METROPOLITAN GOVERNMENT OF NASHVILLE AND DAVIDSON COUNTY

STAFF RECOMMENDATION
144 Windsor Drive
November 7, 2017

Application: New construction—addition violation
District: Belle Meade Links Triangle Neighborhood Conservation Zoning Overlay
Council District: 23
Map and Parcel Number: 13001008600
Applicant: Jackie Daniel, Owner
Project Lead: Melissa Baldock, Melissa.baldock@nashville.gov

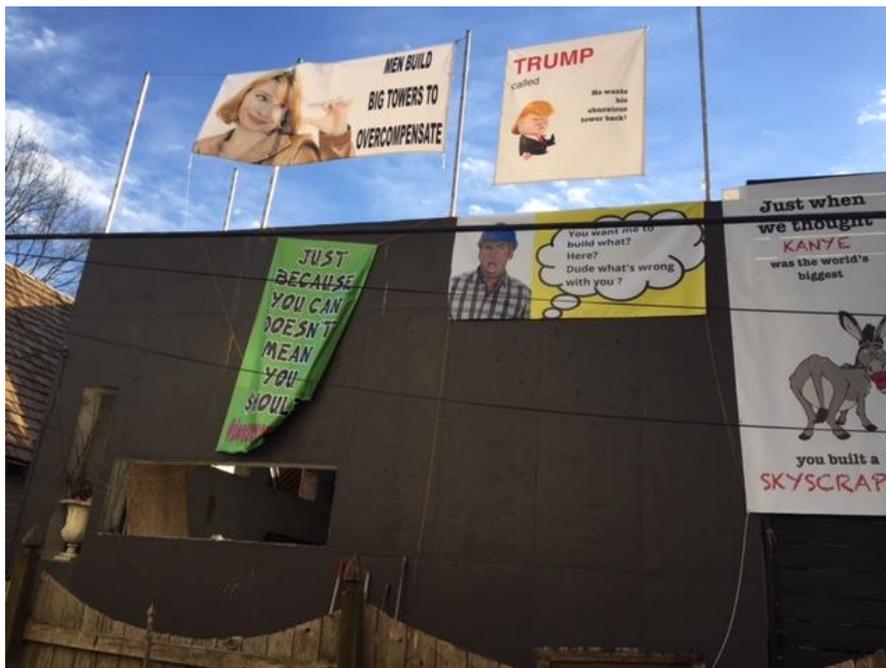
Rear of house taken from the back fence, prior to construction of the 2011 addition.

Rear of home with approved 2011 rear addition and with green-wall under construction that was approved with conditions after-the-fact by the Commission in May 2017. (MHZC does not review signage in this district.)

Rear of home seen beyond neighbor's fence. The unpermitted addition is seen to the far left of the blue wall, and the green screen is just beyond.

Alligator head that is part of the rear addition.

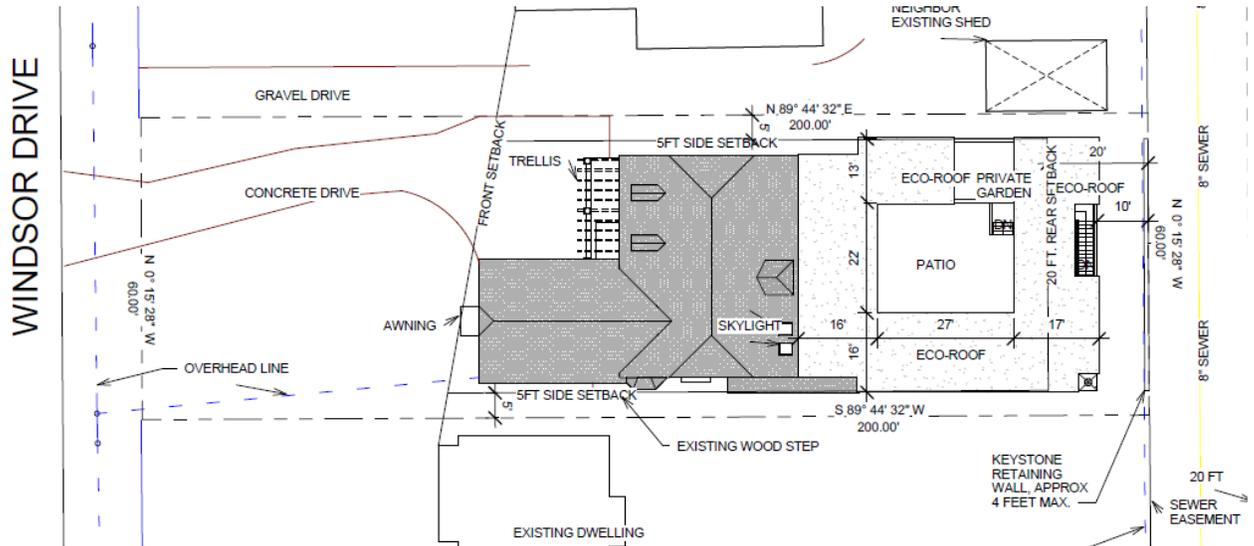
A dinosaur head is also noted on the plans. It is unclear as to whether or not the head is planned to be added. This dinosaur head is from the same company that provided the other two animal heads.
